BGA ENGINEERING

Number 6, May 2001

TITLE	T65 'VEGA' Central Elevator Hinge on Tailplane, Elevator Tongue & Pivot Bearings for Elevator Rocker Arm.	T.I. No. 104/T65 Iss.2
CLASSIFICATION	C.A.A. Mandatory	
COMPLIANCE	Inspection to be carried out before the next flight unless LTO 'Elevator & Canopy Jettison Mechanism', 20th August has been carried out.	
OBJECTIVE	To ensure structural integrity of the central elevator hinge on tailplane elevator drive tongue and to inspect the pivot bearings for the elevator rocker arm assy. Also to reinforce central elevator hinge on tailplane.	
JUSTIFICATION	Cracking and a lack of stiffness has occurred in the area 'A' (Fig 1), the cause of which is attributable to heavy landings and/or excessive bearing loads during elevator assembly.	
APPLICABILITY	All Slingsby T65A, C, D gliders, including spare tailplane/elevators expanding on CAA Airworthiness Directive No.008-08-82. (LTO 'Elevator & Canopy Jettison Mechanism', 20th August).

FIG 1 Area of Cracking on Vega T-Plane

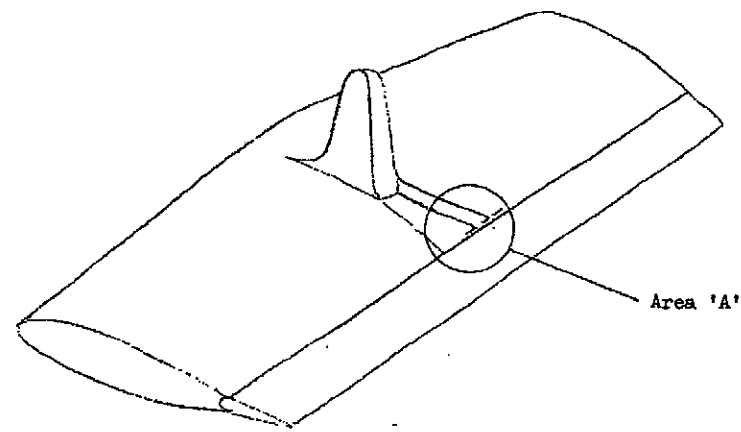
1.3	Inspect the tailplane centre hinge pin mounting rib at the section just forward of the hinge pin as detailed in Fig 6. If cracks or damage are found a repair entailing the fitting of a new 'reinforced' rib will be required. The repair scheme is detailed in Section 4 and should be undertaken by S.A.L. or an approved repair shop. If the section does not show signs of cracking a reinforcement cloth will be required as detailed in Section 5. Alternative means of repair for minor cracking may be carried out with the agreement of SAL.	
	Note - Use Epikote 162/Epikure 113 resin system throughout.	
ISSUED BY:	<i>B. Miller</i>	Date 22nd Sept 82
for and on behalf of	SLINGSBY ENGINEERING LIMITED Kirkbymoorside, York YO6 6EZ, England. Tel. 0751 31751 Telex 57911	Page 1 of 7

FIG 2 Reinforcement of Elevator-Tongue

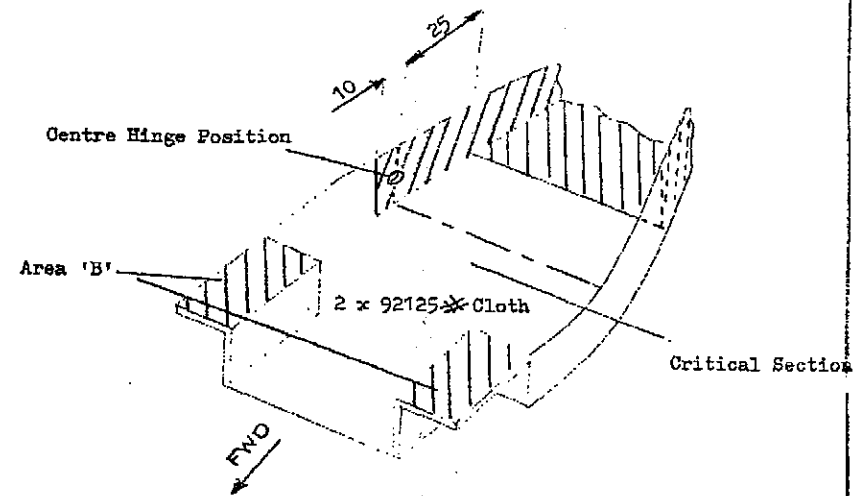
(a)	Remove the tailplane/elevator assembly from the aircraft.	
(b)	With the elevator removed from the tailplane, abrade the tongue of the elevator over the area detailed in Fig 2.

- (j) When fitting the tailplane elevator assembly ensure the elevator tongue seats correctly on the actuator. If there is a clearance between the tongue and actuator the tongue must be built up in the Area 'B' detailed in Fig 2. If there is a foul between the tongue and actuator, the tongue must be trimmed (refer Area 'B' Fig 2) to seat properly on the actuator. Build up the cloth under the flanges and around the web to compensate for any cloth removed.

Only layup cloth on the inside of the tongue on the area NOT shaded.

FIG 3 Actuator Pivot Bearing

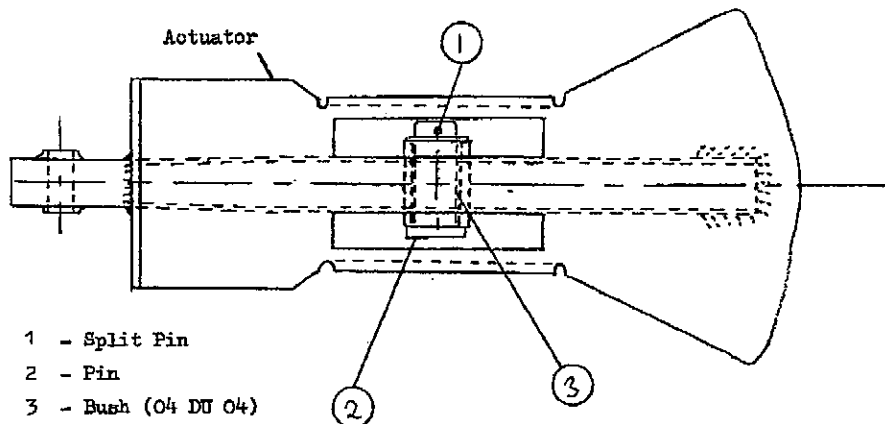
(a)	Remove the tailplane/elevator assembly from the aircraft.	
(b)	Remove the split pin (Item 1) and washer from the central hinge of the actuator (located on top of fin).

(c)	Remove pin (Item 2).	
(d)	Disconnect the pushrod on the fwd end of the actuator (similar to above).	
(e)	Drift the bush from the elevator actuator assembly and replace with new bush (04 DU 04), available from S.A.L.

FIG 4 View of Central Section of T.Plane with the top skin removed.

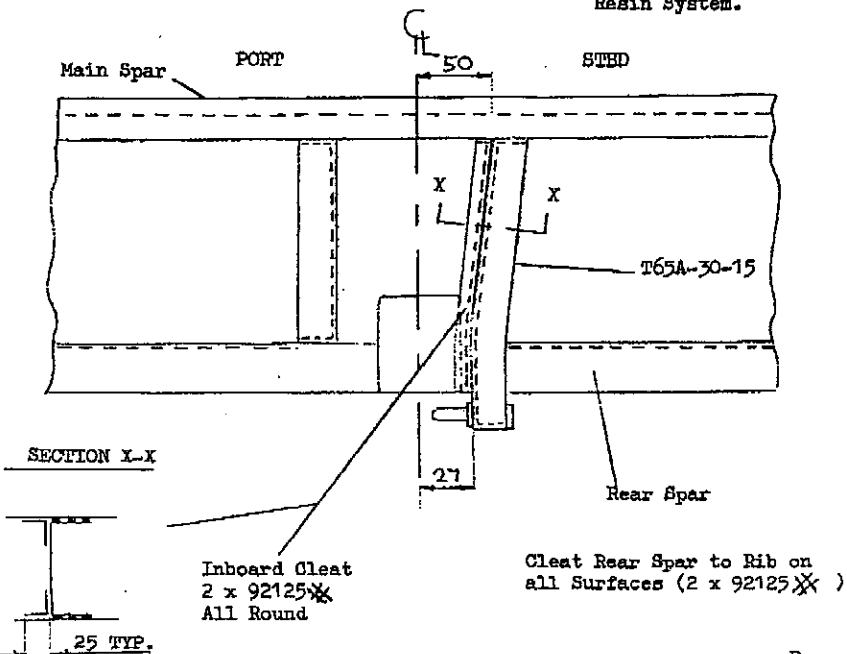
(f)	New split pins must be fitted when reassembling.	
4.1	Replacement of the central tailplane rib with reinforced rib only available from S.A.L. will be carried out as follows (Refer Fig 4).

(e)	Coat the rib with glassflock and initially position the rib to the dimensions detailed in Fig 4.	
(f)	Position the tailplane in trestles as shown in Fig 5.	
ISSUED BY:	<i>B. Miller</i>	Date 14th Sept 82
for and on behalf of	SLINGSBY ENGINEERING LIMITED Kirkbymoorside, York YO6 6EZ, England. Tel. 0751 31751 Telex 57911	Page 2 of 7

- 4.1 (g) Fit the elevators checking the split pin hole is accessible. The rib should now be correctly positioned.
- (h) Carefully remove the elevators and apply the cleat cloths as detailed in Fig 4.

Use Epikote 162 Epicure 113
 Resin System.

FIG 5 Positioning of Elevators

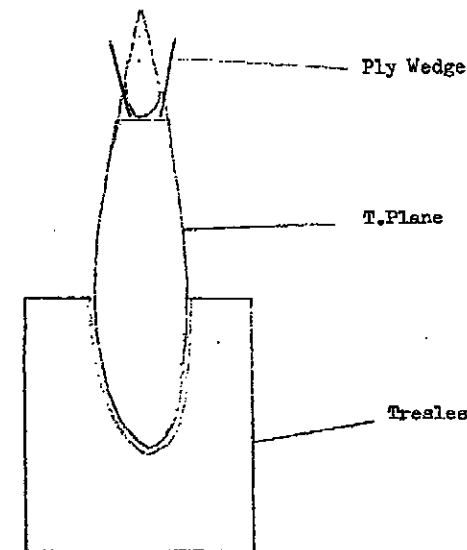
- (i) The elevators should now be repositioned to ensure the rib is still located in the correct position. The elevators should be pushed fully home again ensuring the split pin hole is accessible. Position wedges as shown in Fig 5 to hold the elevators in the neutral position.

FIG 6 Reinforcement Cloth on the Centre Tailplane Hinge

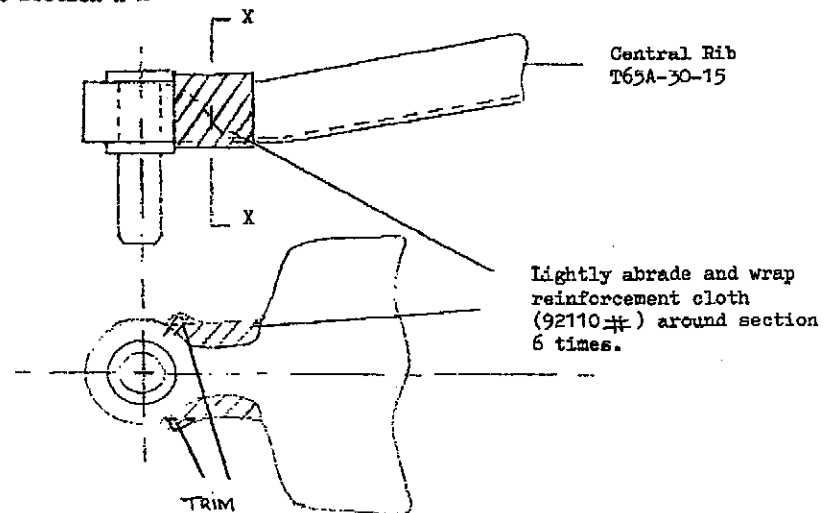
- (b) When the elevator is removed from the tailplane, lightly abrade the area shown in Fig 6.
- (c) Wrap a 10mm strip of 92110 # woven roving cloth 6 times around the area detailed.

Inspect Section X-X
